Re: St. Johns-Pellicer-Pringle 230-kV Certified Transmission Line Siting Act (TLSA)
Project Modification- Responses to Request for Additional Information
DEP Case Number TA05-13A
OGC Case Number 09-3192

**FPL ST. JOHNS-PELLICER-PRINGLE
230-kV TRANSMISSION LINE PROJECT
CORRIDOR MODIFICATION
COMPLETENESS RESPONSES**

ATTACHMENT NEFRPC-1

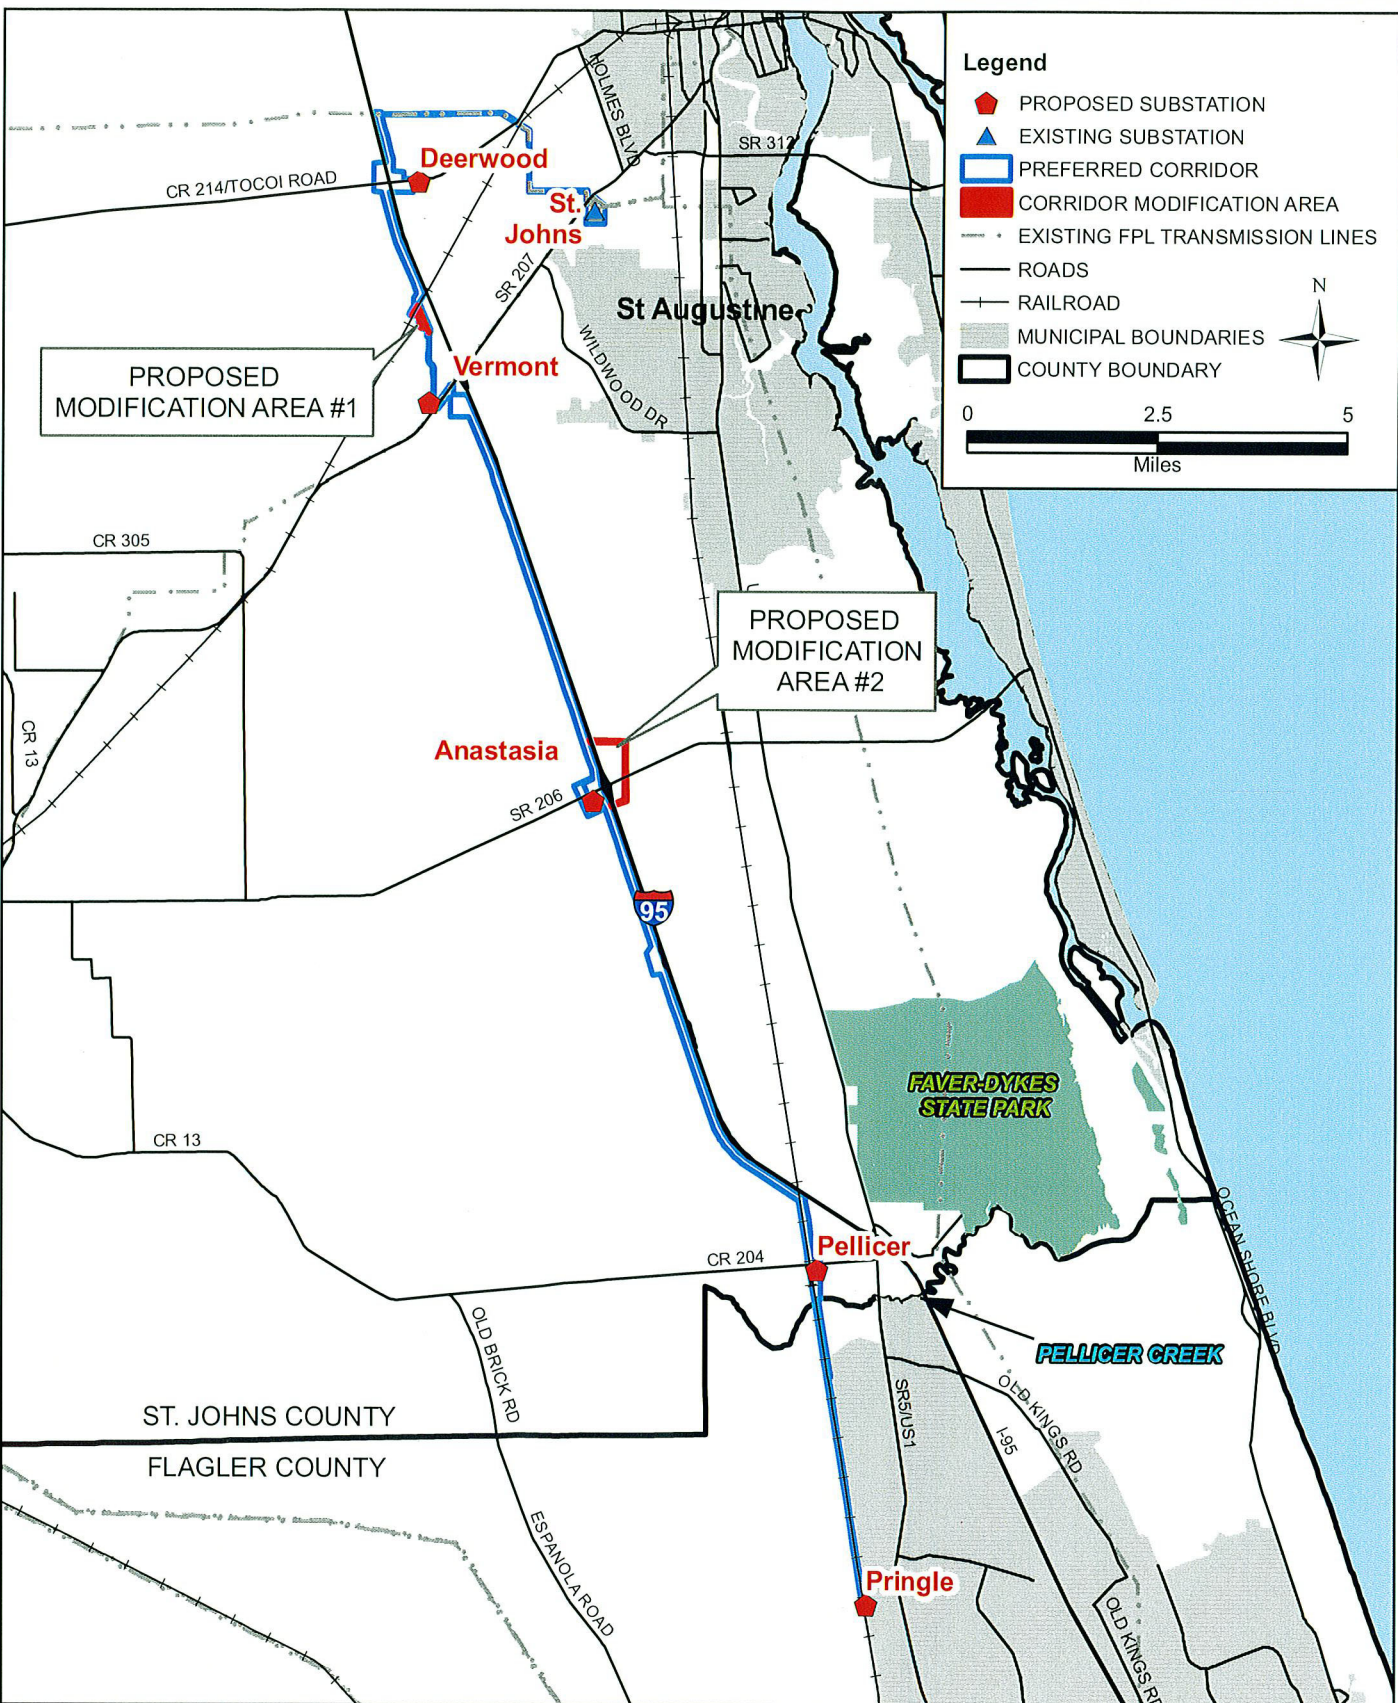
- 1. Pellicer Creek and Faver Dyke State Park are natural resources of Regional significance as sited in the Council Strategic Regional Policy Plan (SRPP). Please provide the necessary information as to the proximity of the corridor modifications to these resources.***

Pellicer Creek and Faver-Dykes State Park are both found several miles southeast of the two proposed modification areas, as shown on Attachment NEFRPC-1. The closest distances from the two modification areas to these natural resource features are as follows:

Distance to Pellicer Creek	Distance to Faver- Dykes State Park
Modification Area #1	14.0 miles	10.2 miles
Modification Area #2	7.4 miles	3.8 miles

Based on these distances, Florida Power & Light Company's (FPL's) two proposed modification areas will have no impact on these features.
